Regulation No. 110 (Specific components for CNG)

Proposal for draft 02 series of amendments to Regulation No. 110

Submitted by the expert from the Netherlands*

The text reproduced below was prepared by the expert from the Netherlands to regulate the direction of discharging the Compressed Natural Gas (CNG) container(s). It supersedes ECE/TRANS/WP.29/GRSG/2014/29. The modifications to the current text of Regulation No. 110 are marked in bold characters.

Arrangement of the CNG/LNG component type approval mark

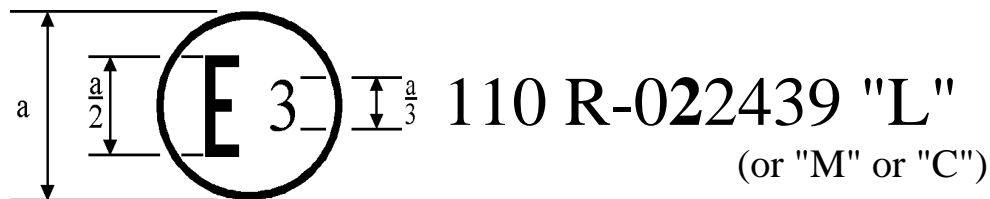
Annex 2A, amend to read:

The above approval mark affixed to the CNG and or LNG component shows that this component has been approved in Italy (E3), pursuant to Regulation No. 110 under approval number 022439. The first two digits of the approval number indicate that the approval was granted in accordance with the requirements of Regulation No. 110 as amended by the 02 series of amendments.

Model B

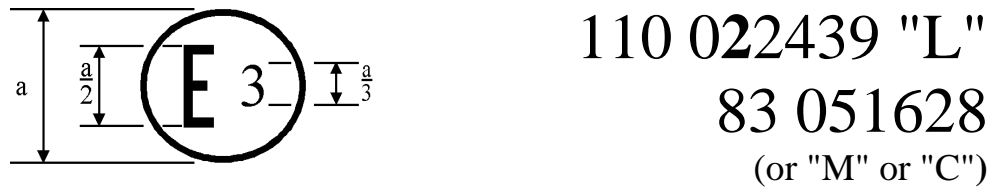
The above approval mark affixed to a vehicle shows that the vehicle has, with regard to the installation of CNG/LNG system for the use of natural gas for propulsion, been approved in Italy (E3), pursuant to Regulation No. 110 under approval number 022439. The first two digits of the approval number indicate that at the date the approval was granted in accordance with the requirements of Regulation No. 110 as amended by the 02 series of amendments and that Regulation No. 83 included the 05 series of amendments.
